From: [Miller, Garyg](#)
To: [David Keith](#)
Cc: [Sanchez, Carlos](#); [Walters, Donn](#); [Foster, Anne](#)
Subject: FW: San Jacinto
Date: Wednesday, December 16, 2015 9:24:00 AM
Attachments: [0557-QIR-003 \(with Probe Locations\).pdf](#)

As we discussed, please see the attached map and the email below. During the underwater inspection of the cap at the San Jacinto River Waste Pit Superfund Site last week on December 9 and December 10, 2015, the EPA Dive Team found an area located in the Northwest part of the cap where the armor rock was missing. The cap in this area consists of size "A" recycled concrete material (80% with median rock diameter 3-inches, and 20% filter gravel) with a minimum cap thickness of 12-inches. The exact area of displaced armor rock is unknown, but was at least 17-feet across.

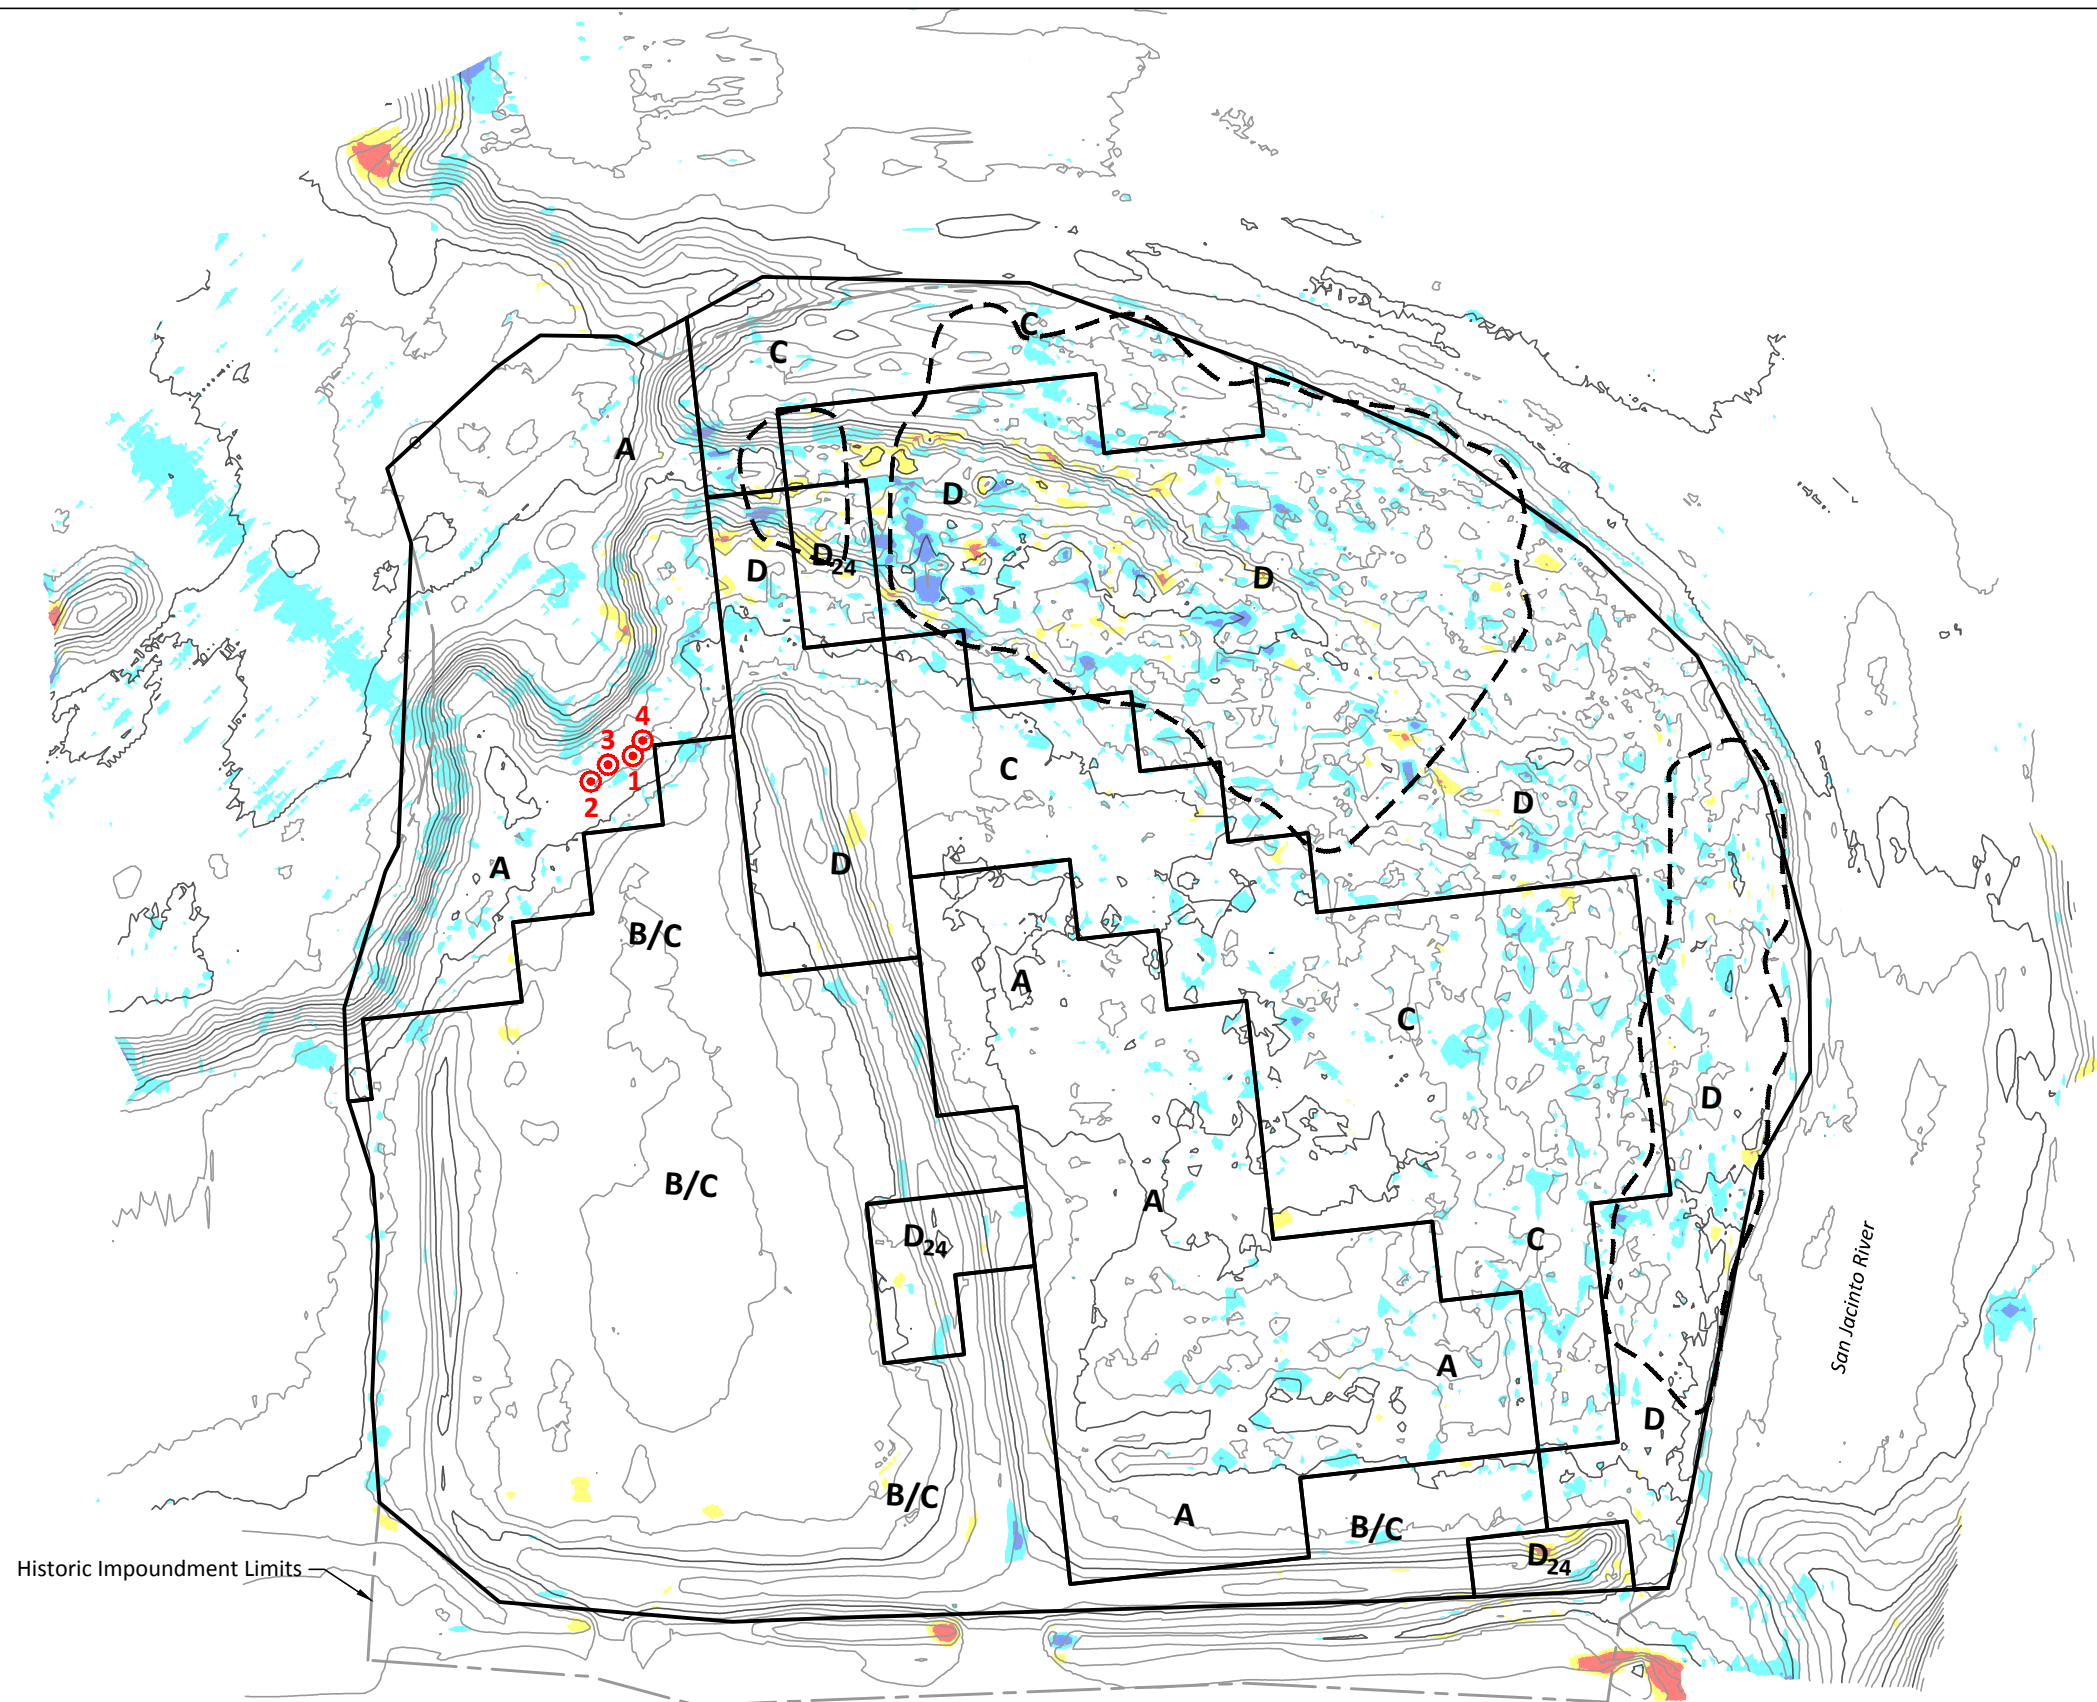
In accordance with the Operations, Monitoring, and Maintenance Plan, please prepare a repair plan, including delineation of the extent of the armor displacement area and collection of surface sediment samples for dioxin/furan congener analysis, and proposed cap maintenance for the above referenced area, including quality assurance and quality control procedures. The repair plan should also include an expedited schedule and a description of the initial construction and inspection activities and results for this area.

We gave Holly the four probe GPS points done on the "gap" in the armor cover in the northwest area and she had them dropped onto a base map. I was busy with the sonar so others know better, but the probe hit armor at points 2 and 4 and soft sediment at points 1 and 3, which lie between points 2 and 4. The distance between points 1 and 3 is 17 feet, but the actual length of the soft sediment patch W-E is a minimum of 17 feet and perhaps greater, not sure of the total area.

During the probing yesterday morning, your team hit rock at locations 2 and 4. Locations 1 and 3 are the two points where sediment was encountered.
